**PROPOSED SUBDIVISION
WEST COAST ROAD WAIPAPAKAURI; LOT 2 DP 394720
RESPONSE TO REQUEST FOR FURTHER INFORMATION (TRAFFIC)
FAR NORTH DISTRICT COUNCIL REF. 2260100-RMASUB**

1. This is a response to item 1 of a request for further information (RFI) in relation to the application for this subdivision, which is:

Fig. 1
Sightlines
Both
Directions

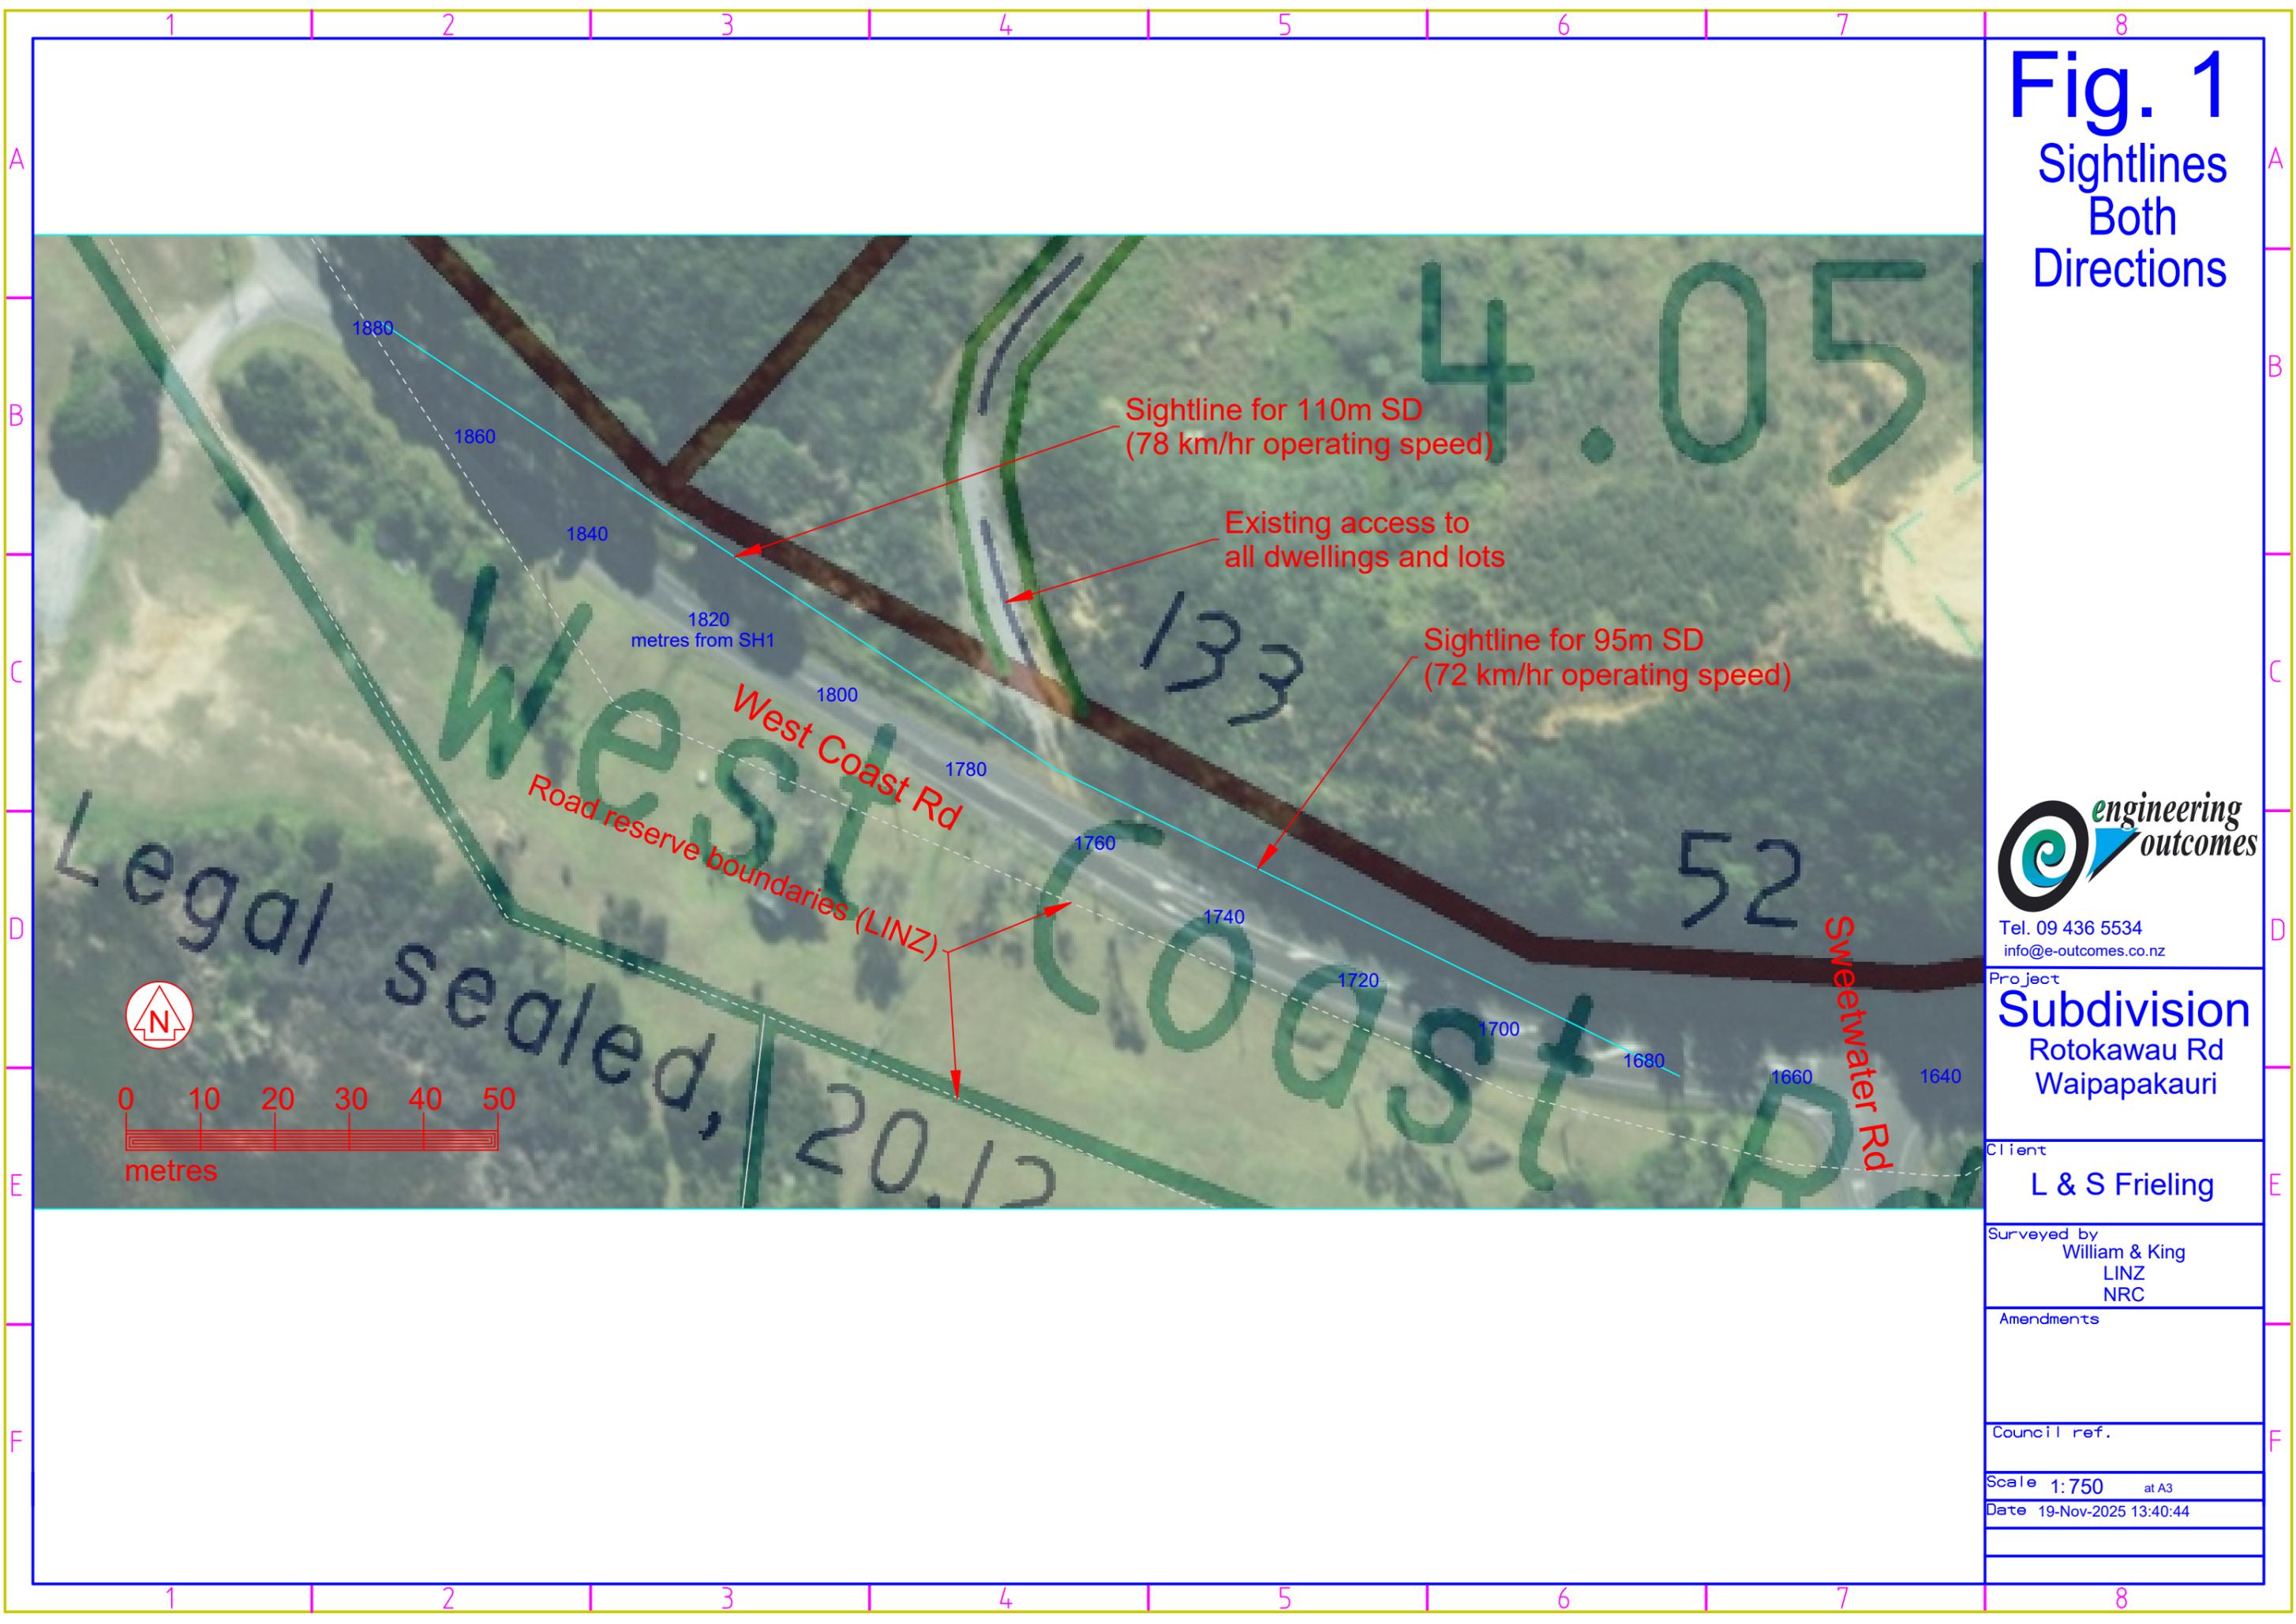
Please provide clarification regarding the sight distance for the entrance, specifically confirming whether it complies with the relevant engineering standards. As per Councils roading teams review, the sight distances to the crossing do not meet the requirements set in the Engineering Standards. If it does not meet the required standards, kindly outline the proposed measures to mitigate any associated effects.

7. The operating speeds are 72 km/hr westbound and 78 km/hr eastbound for which the complying sight distances are 95 and 110 metres respectively. Sightlines for those sight distances are plotted in Figure 1.

8. The available sight distances are somewhat below those standards in both directions – 75 metres towards the west and 102 metres towards the east. However, according to a ground model constructed from LiDAR data, both sightlines are everywhere above the ground surface.

10. Neither complying sightline is consistently 2 metres above the ground surface as indicated by the LiDAR data, so it is possible that some earthworks will be necessary. Even if earthwork proves necessary, those will be relatively minimal and entirely in sandy ground² where there is minimal chance of destabilisation of the slopes above. Even so, if necessary, all earthworks should still be assessed by a geotechnical engineer at the design stage post-consent³.
